**TOWN OF NEWBURGH  
PLANNING BOARD  
TECHNICAL REVIEW COMMENTS**

**PROJECT NAME:** NEWBURGH CHICKEN, LLC - POPEYES  
**PROJECT NO.:** 23-17  
**PROJECT LOCATION:** 197 SOUTH PLANK ROAD  
SECTION 60, BLOCK 3, LOT 6.1  
**REVIEW DATE:** 22 JANUARY 2024  
**MEETING DATE:** 1 FEBRUARY 2024  
**PROJECT REPRESENTATIVE:** DYNAMIC ENGINEERING

**RE: Newburgh Chicken, LLC  
Proposed Site Improvements  
Section 60, Block 3, Lot 6.1  
197 South Plan Road  
Town of Newburgh  
Orange County, NY  
DEC # 1021 22-01041**

TITLE: **SITE PLAN**

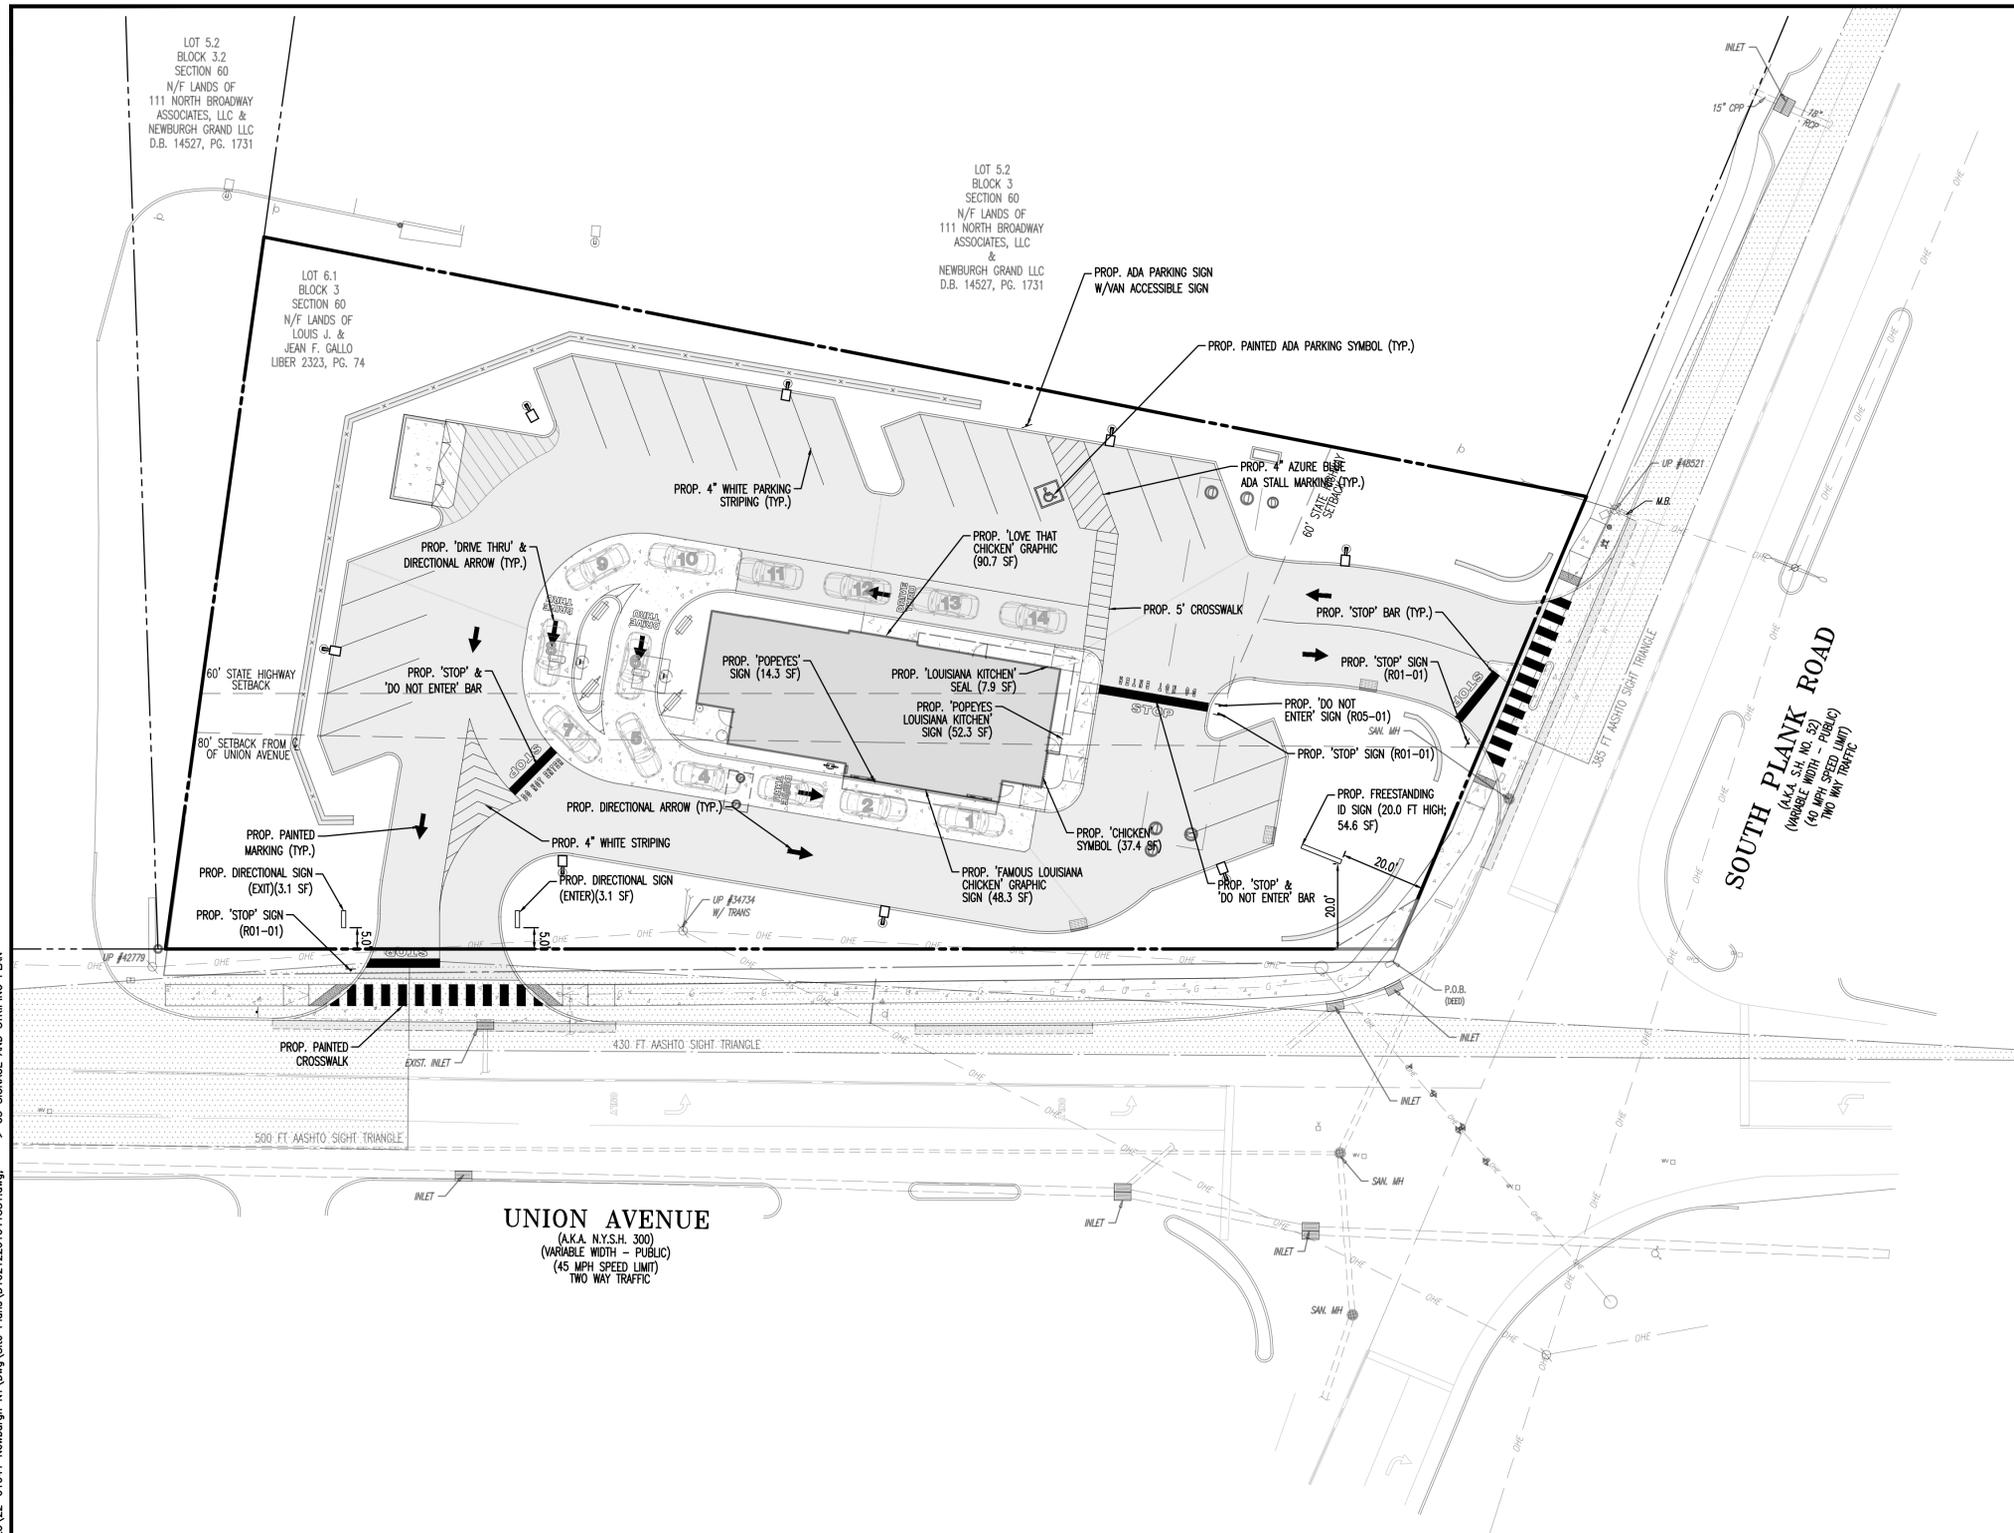
2. *Because proposed retaining walls on site are so tall, geogrid may be needed as part of the design of the walls. There are existing trees along the southern property line that provide screening and greenery to this stretch of Route 300. If geogrid is needed, trees will need to be removed from the top of the proposed retaining wall which would negatively affect visual impacts of the site. Please also record the size and species of trees on the neighboring property within 10' of the property line to help determine if the trees will survive and be stable once the geo-grid for proposed walls is installed. Accurately show clearing limit lines, taking into account the area needed for geo-grid.*

3. *Dry laid stone walls 30-36" in height are included in the Town of Newburgh design guidelines as a desirable site feature which contributes to the Town of Newburgh sense of place. There are many opportunities on the site to include these stone walls such as large curving arcs along the entrances and around corners of the property. These walls would be a particularly welcome addition to the site plan as this is a highly visible site on a busy intersection.*

1. *Planning Board should discuss the need for continuation of sidewalks along the entire property frontage as is standard practice for the Town of Newburgh on State highways.*

**The Site Plan (sheet 4 of 20) has been revised to propose a gravity block retaining wall, which will not require a geogrid and therefore, will have less impact on the surrounding trees. A full tree survey is being conducted and will be provided under separate cover on a future technical revision of the Site Plan drawings.**

**The Site Plan (sheet 4 of 20) has been updated to propose three (3) dry laid stone walls along the property frontage.**

**The Site Plan (sheet 4 of 20) has been revised to continue the sidewalk along the entire property frontage.**

**The Site Plan (sheet 4 of 20) has been revised to propose a right-in/right-out driveway along NYS Route 52.**

**The Site Plan (sheet 4 of 20) has been revised to provided adequate spacing between the retaining wall and the western property line. A full retaining wall design will be included as a part of a future technical revision.**

TITLE: **SIGNAGE AND STRIPING PLAN**

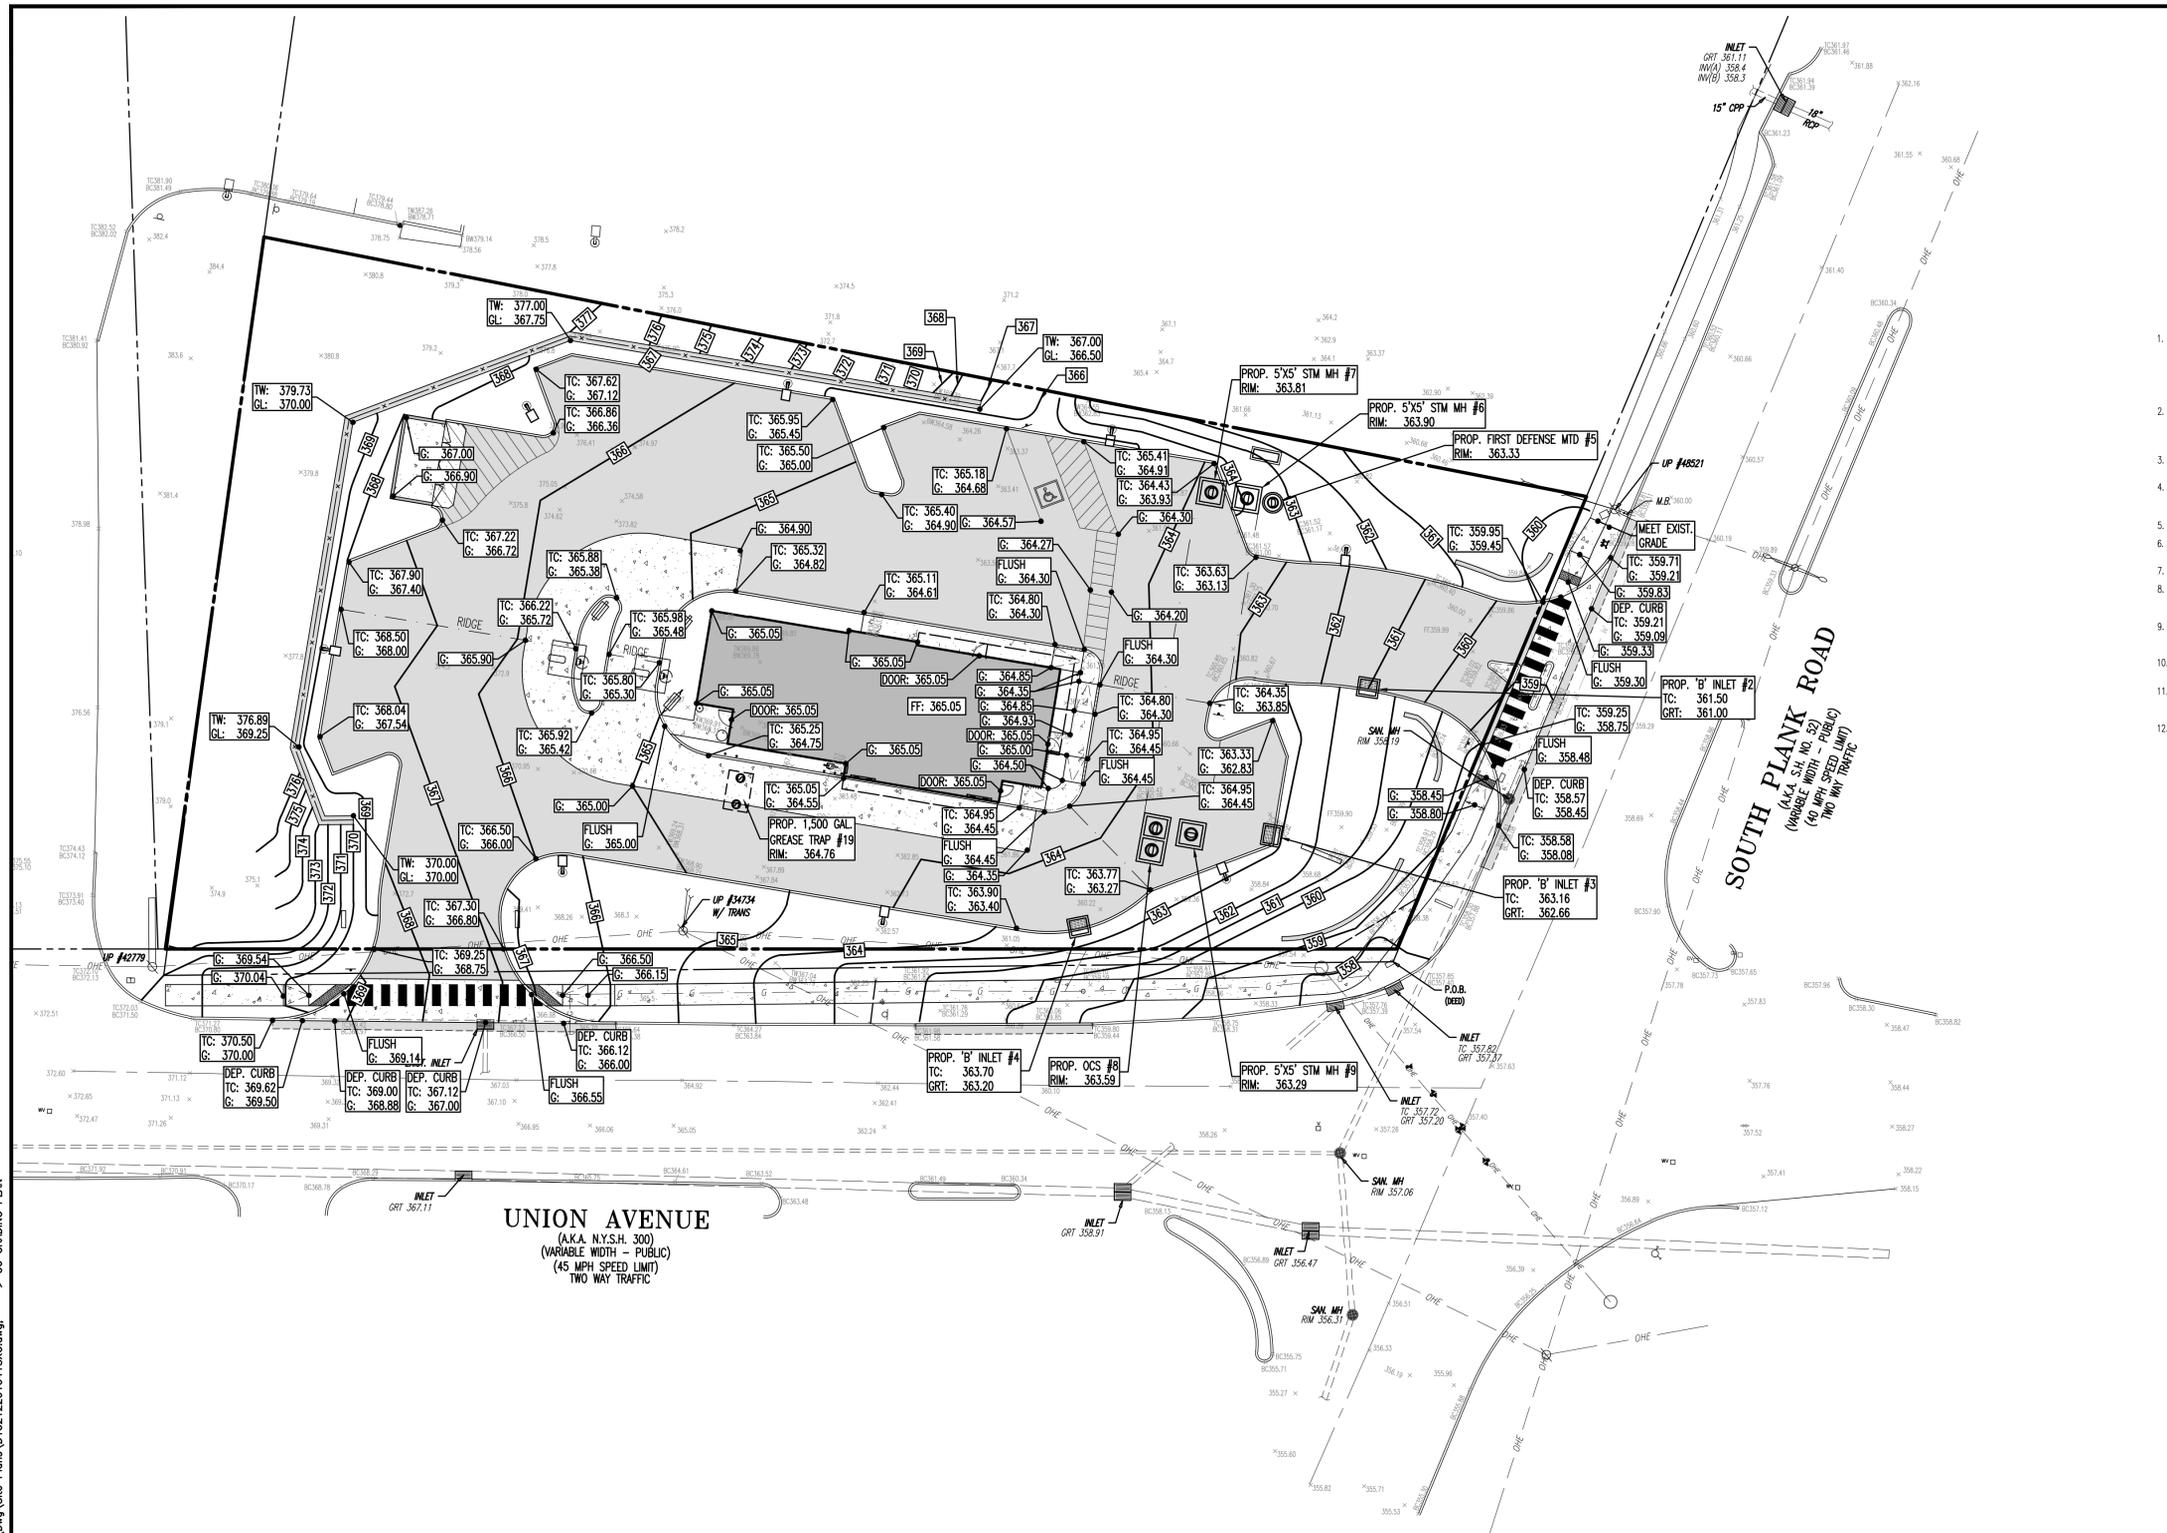
11. The project requires architectural review by the Planning Board. It is noted a free-standing sign is proposed with a 20-foot height, measuring 54.6 square feet in size. The sign detail identifies 20-25 feet high. 20-foot maximum height is permitted based on setback provided.

12. Town of Newburgh requires parking spaces be painted with a double line, typical detail is attached.
13. The Planning Board may wish to consider whether to have a Public Hearing for the project, the project is a Type II action with no additional SEQRA required, and County Planning referral has timed out.

TITLE: **DRAINAGE PLAN**

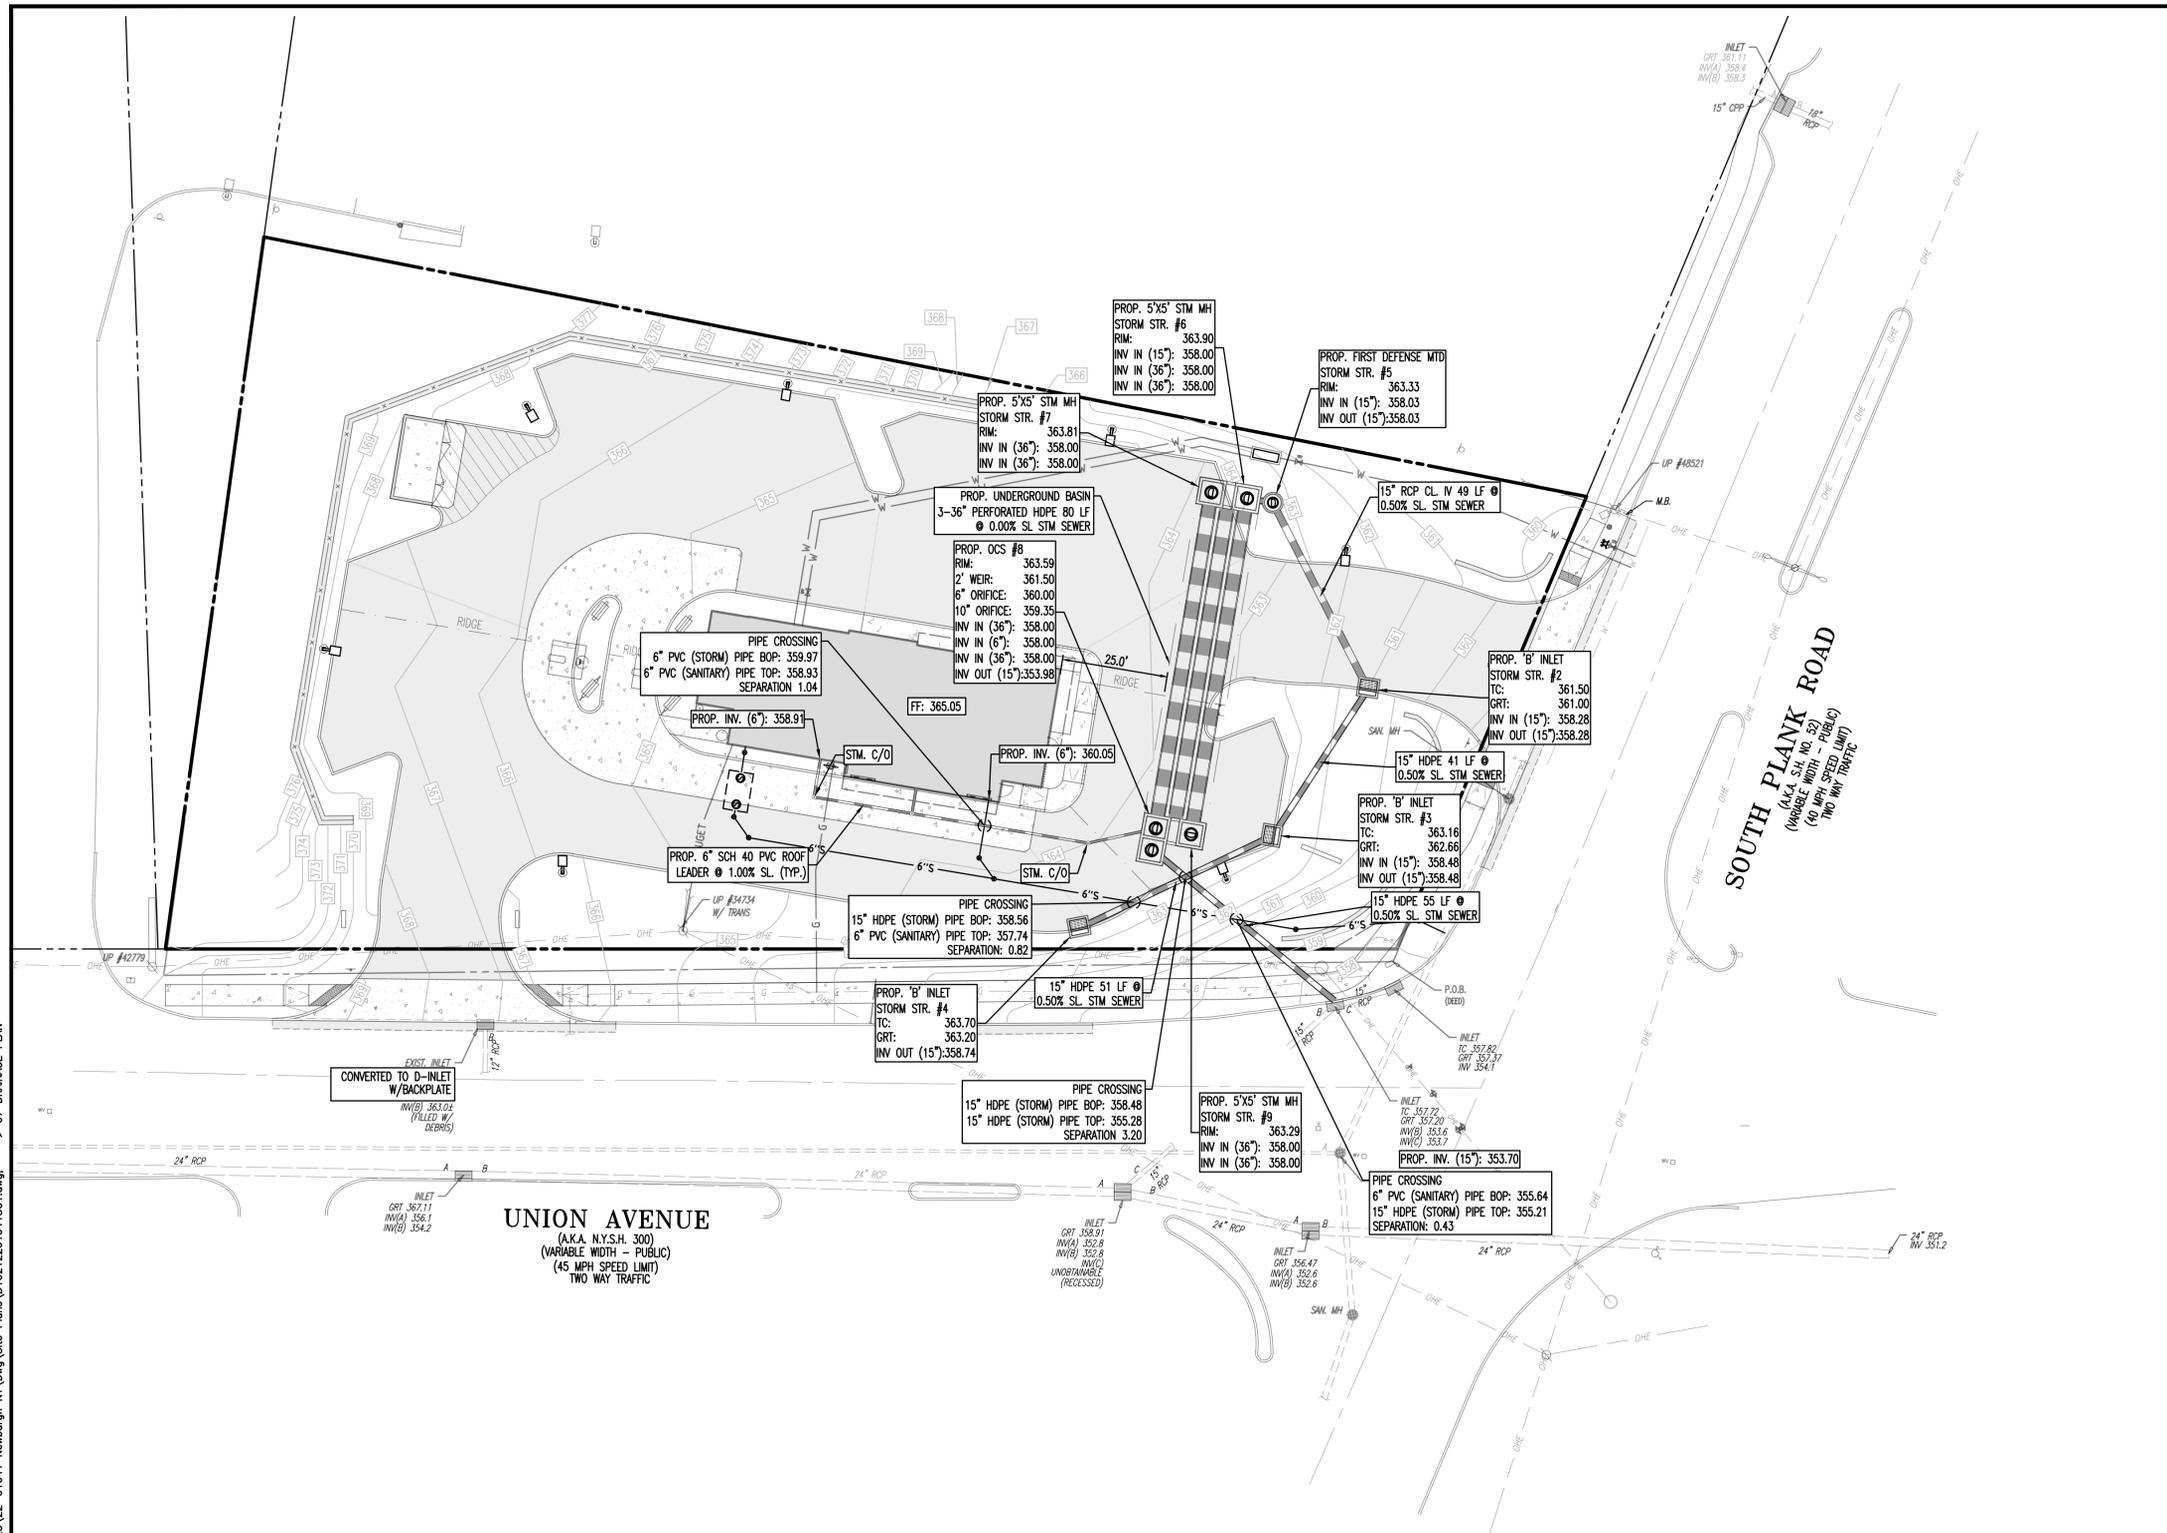
10. *The plans identify 43,130 square feet of disturbance. This equates to 0.99 acres. The applicants have identified that they are not required to receive coverage under the NYSDEC Stormwater SPDES Permit. This office recommends coverage under the permit to protect both the Town of Newburgh and the applicant from any circumstances which result in excavation, land disturbance or other activities including utility connections which are not currently identified on the plan to exceed one acre threshold. Project is in a very visible are / high traffic area such that review by outside agencies may occur.*

**The Drainage Plan (sheet 7 of 20) has been revised to incorporate a full stormwater design for coverage under the NYSDEC Stormwater SPDES Permit. We have also enclosed the updated Stormwater Pollution Prevention Plan (SWPPP). Please note, assumptions were made with respect to the seasonal high water table and permeability rates of the subsurface soils. Soils testing is being conducted and the design will be revised to address any changes as a result of the testing.**
